FUSELAGE - TAILCONE ACCESS DOOR WATER DRAINAGE IMPROVEMENT MODIFICATION

**EFFECTIVITY****MODEL**Model 700 (Citation  
Longitude)**SERIAL NUMBERS**

-0001 thru -0031

SB700-53-01  
Page 1 of 4

Figure 1. Tailcone Access Door Water Drainage Hole Location (Sheet 1)

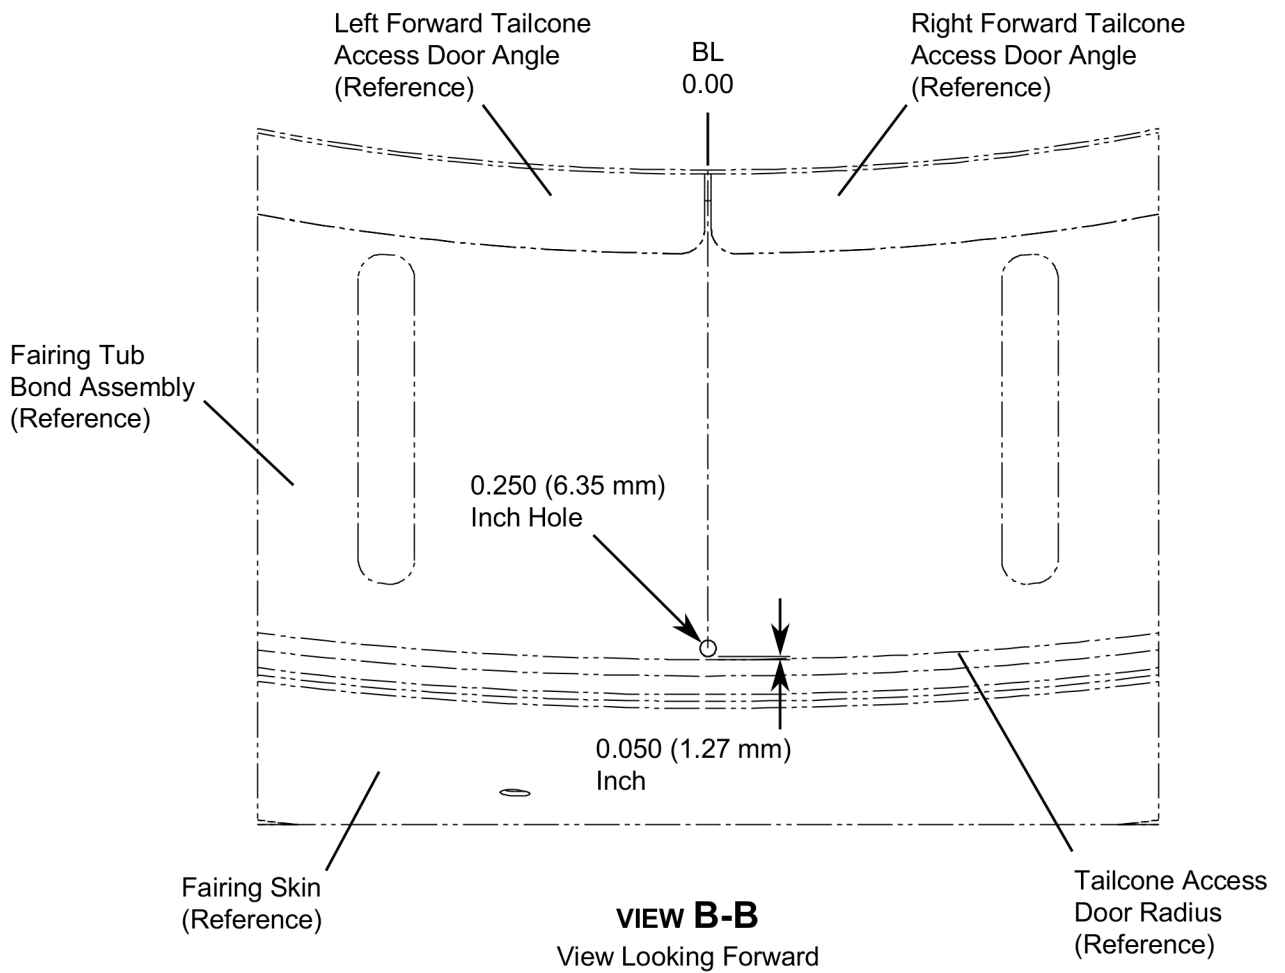
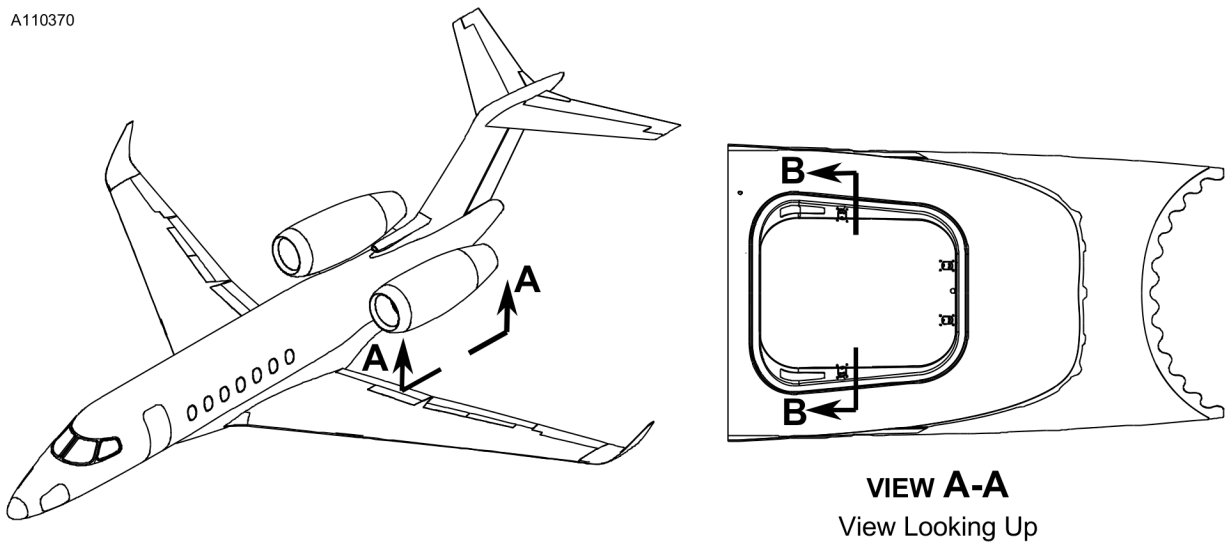
To add a drain hole in the aft fairing tub assembly to prevent water collection on the tailcone access door.

This service bulletin provides instructions to drill a 0.250 inch (6.35 mm) diameter drain hole in the aft fairing tub assembly that will prevent water collection on the tailcone access door.

2. (Refer to Figure 1, Detail A) Fabricate a drain hole in the aft fairing tub assembly as follows:
  - A. Open the tailcone access door. (Refer to Cessna Model 700 Maintenance Manual, Chapter 6, Dimensions and Areas - Description and Operation.)

- B. (Refer to Figure 1, View A-A.) Using an indelible marker, mark the location of the drain hole on the fairing tub bond assembly.
  - C. Drill one 0.250 (6.35 mm) inch diameter hole at the marked location on the fairing tub bond assembly using a 0.250 (6.35 mm) inch drill bit.

- D. Deburr the drilled hole.
  - E. Apply a thin coat of U000948 epoxy adhesive to the edge of the drilled hole.
  - F. Close the tailcone access door. (Refer to Cessna Model 700 Maintenance Manual, Chapter 6, Dimensions and Areas - Description and Operation.)
